December 27, 2024

CITY OF FORT LAUDERDALE – URBAN DESIGN & PLANNING
700 NW 19TH AVENUE
954-828-5018 – LTappen@fortlauderdale.gov

Re: **YMCA/Broward Health at Holiday Park – 840 N Federal Hwy) (DRC Case #UDP-S24057)**
INITIAL SUBMITTAL – October 22, 2024

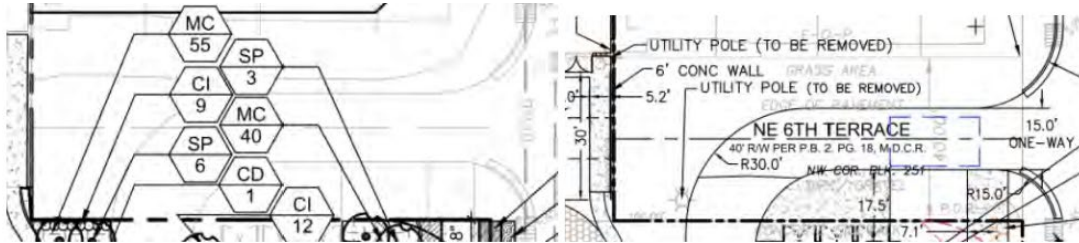
1. A minimum separation of 6 feet is required between the tree trunk and travel lane when curb and gutter DO NOT exist, and a minimum separation of 4 feet is required between the tree trunk and travel lane when curb and gutter DO exist. Illustrate this clearance on the landscape plan, i.e. along NE 7th Avenue.

RESPONSE: Added dimensions to the planting for the trees along the street frontages showing compliance with code requirement.

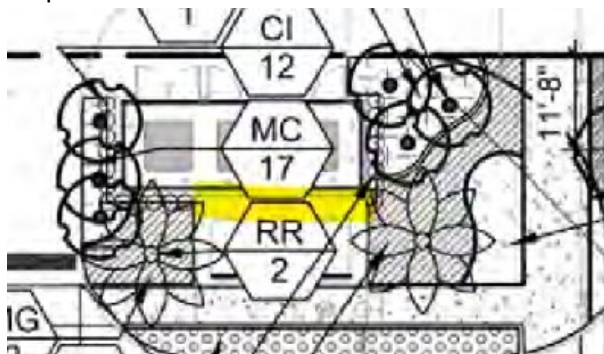
9. Sight triangles located at the intersection of a local street or driveway with a right-of-way under County, State or Federal jurisdiction, may be subject to the sight visibility requirements of those jurisdictions, as per ULDR 47-2.2. Q. Illustrate such sight triangles and provide documentation that application for approval has been made for planting in such right-of-way area.

- a. Approval from jurisdiction for landscape installation in Right Of Way, preferred prior to final DRC sign off. If jurisdiction approval is obtained after DRC final sign off and the plans require any change, Administrative Review will be required prior to permit review.

RESPONSE: Sight Visibility Triangle will not apply to this project as the intersection of NE 8th Street and Federal Highway is a lighted intersection.
